UNITED STATES
DEPARTMENT OF THE INTERIOR
BUREAU OF LAND MANAGEMENT
APPLICATION FOR PERMIT TO DRILL OR REENTER

1a. Type of work: <input checked="" type="checkbox"/> DRILL <input type="checkbox"/> REENTER 1b. Type of Well: <input checked="" type="checkbox"/> Oil Well <input type="checkbox"/> Gas Well <input type="checkbox"/> Other 1c. Type of Completion: <input type="checkbox"/> Hydraulic Fracturing <input checked="" type="checkbox"/> Single Zone <input type="checkbox"/> Multiple Zone		5. Lease Serial No. NMNM102917 6. If Indian, Allottee or Tribe Name 7. If Unit or CA Agreement, Name and No. 8. Lease Name and Well No. CASEY JONES 21 FED COM 733H 9. API Well No. 30-015-55413

PECOS DISTRICT DRILLING CONDITIONS OF APPROVAL

OPERATOR'S NAME:	EOG RESOURCES INCORPORATED
WELL NAME & NO.:	CASEY JONES 21 FED COM 733H
SURFACE HOLE FOOTAGE:	2197'/N & 930'/W
BOTTOM HOLE FOOTAGE:	230'/N & 990'/W
LOCATION:	Section 21, T.26 S., R.30 E., NMP
COUNTY:	Eddy County, New Mexico

Design B**4. CASING PROGRAM**

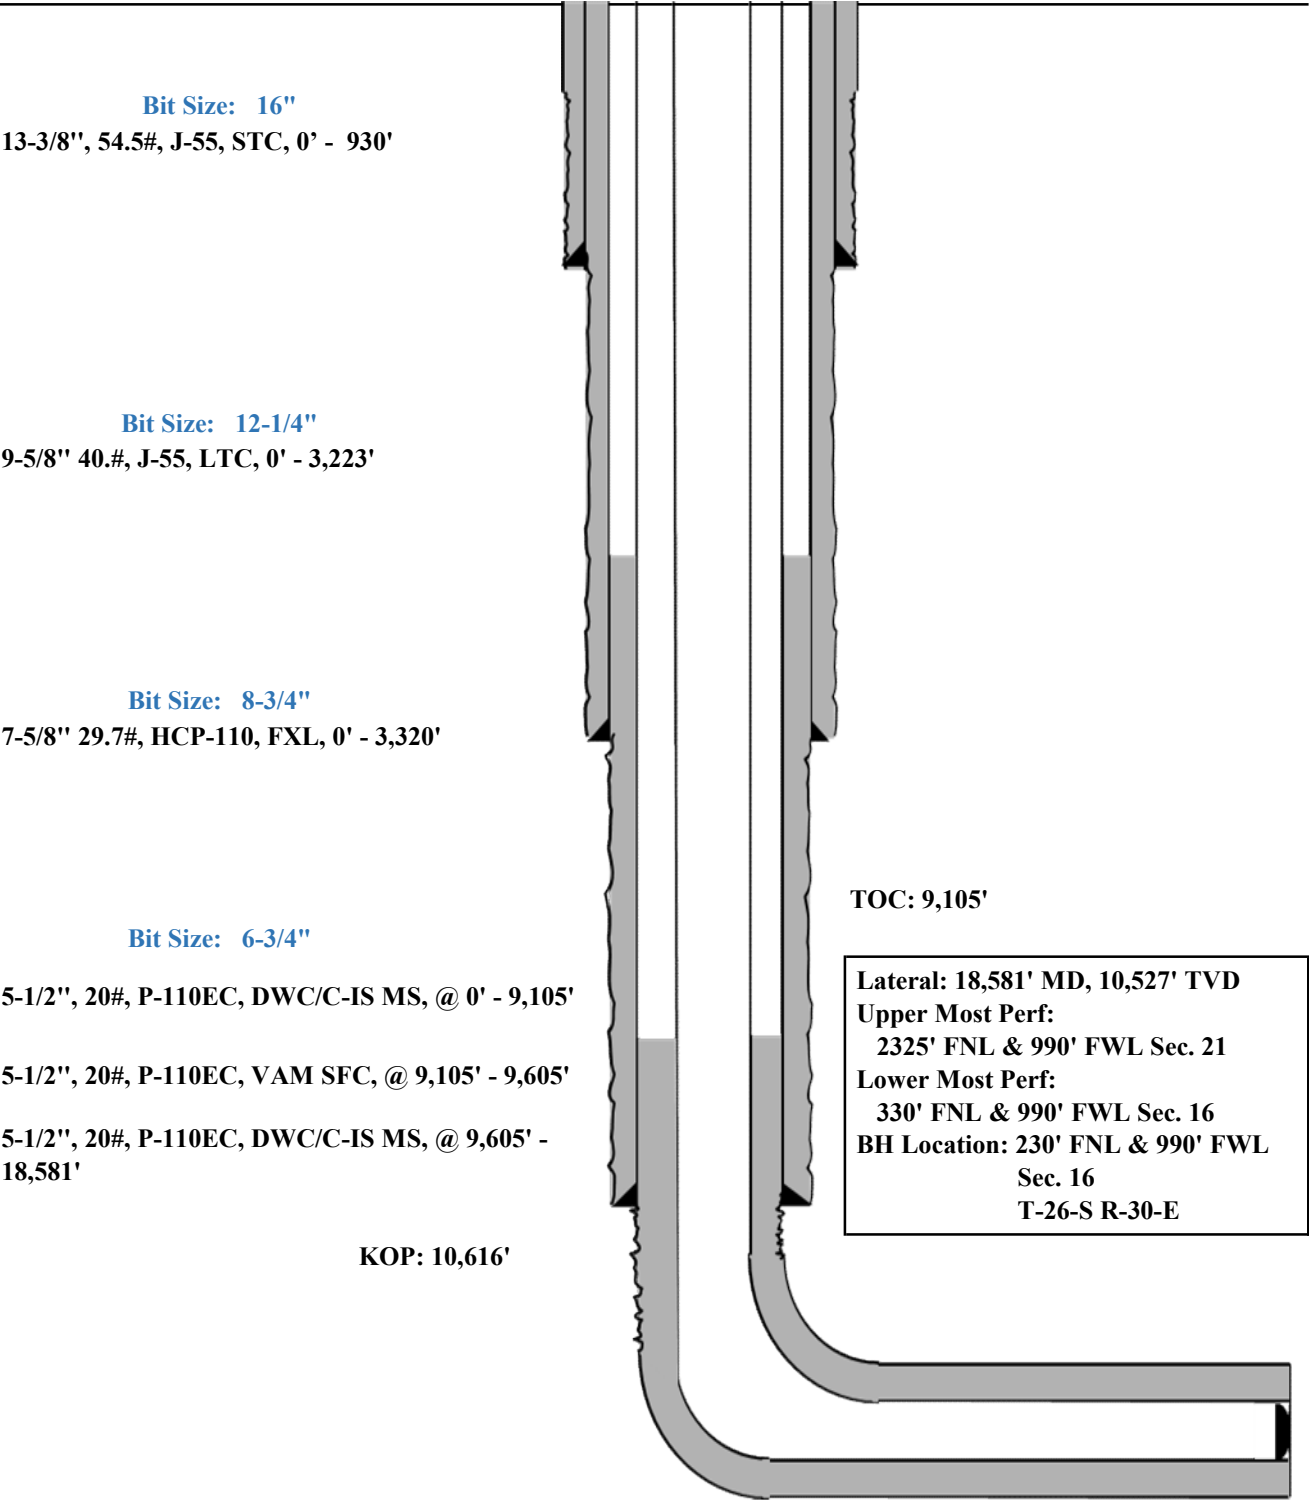
Operator is only approved for Design A. Design B is not to be utilized. If Design B is needed or any other change, please submit a NOI sundry to make the changes.
